MASSACHUSETTS INSTITUTE OF TECHNOLOGY HAYSTACK OBSERVATORY

Subject: Minor adjustments to LNA for improved S11 below 100 MHz.

Figure 1. Adjustments to LNA circuit.

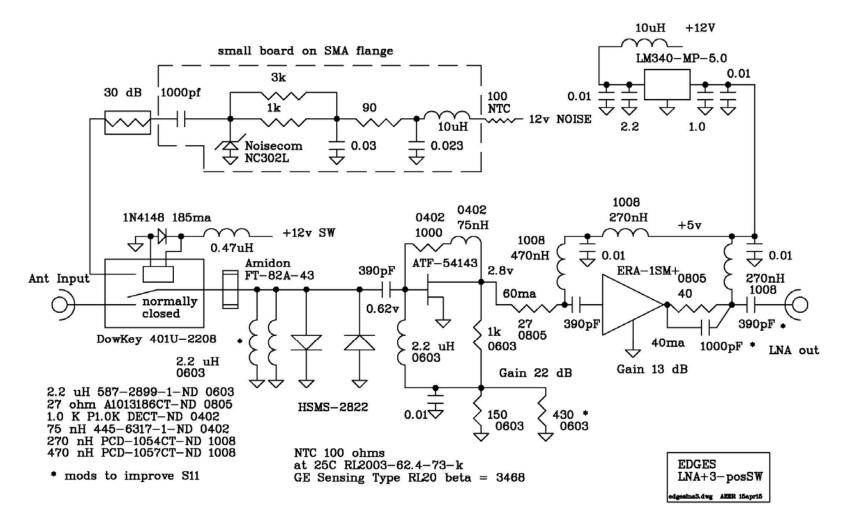
The S11 of the LNA can be improved to be below about -30 dB from 50 to 100 MHz with the following minor adjustments:

- 1. Adding 2.2 μH in parallel with the 2.5 μH inductance on the LNA input.
- 2. Bypassing the 40 ohms on the ERA-1SM output with 1000 pf
- 3. Increasing the 100 pf output coupling from 100 pf to 390 pf
- 4. Slight adjustment in the ATF-54143 bias by putting 430 ohms in parallel with the 150 ohm bias resistor.

These changes made smaller improvements above 100 MHz. While the circuit simulations show that change #1 should improve the low end for all units the other changes may be specific to characteristics of the individual ATF-54143. Changing the 1000 ohm feedback resistor is not easy and was not attempted since small changes in resistance are limited by the available values of resistance. Adding a resistor in series or parallel in this case is not an option as the capacitance of the resistor combination will be significantly different. Change #2 increases the gain by about 3 dB. To get back to about the same gain the attenuator on the output should be changed to 12 dB (Minicircuits BW-S12W2+).
